SUNDRY NOTICES AND REPORTS ON WELLS

E.C. Hill B Fed #19

OXY USA Inc requests to temporarily abandon this well for possible future use, this well is currently being evaluated for a possible Seven River Queen recompleation.

**Temporary Abandonment of Wells on Federal Lands
Conditions of Approval**

OXY USA Inc. - Proposed
E.C. Hill B Federal #19
API No. 30-025-33494

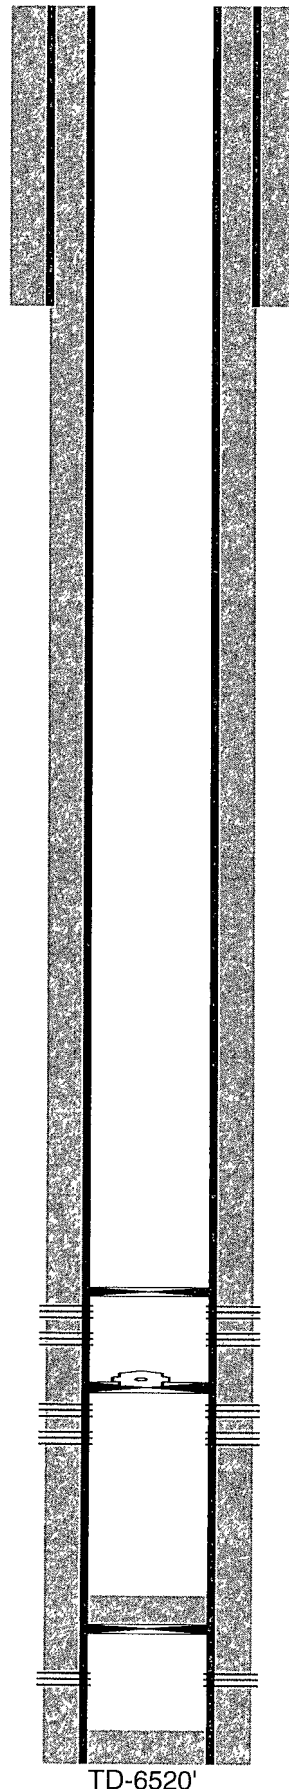
E.C. Hill B Fed. #19. Well may be approved to be TA/SI for a period of 1 Year after successful MIT and subsequent report is submitted. This will be the last and only TA/SI approval. Well must be P&A or plans to return to beneficial use submitted by February 1, 2011. RBP must be capped with cement, 25 sacks if set with tubing or 35' if set with bailer. Notify BLM to witness placement of cement on plugs and MIT.
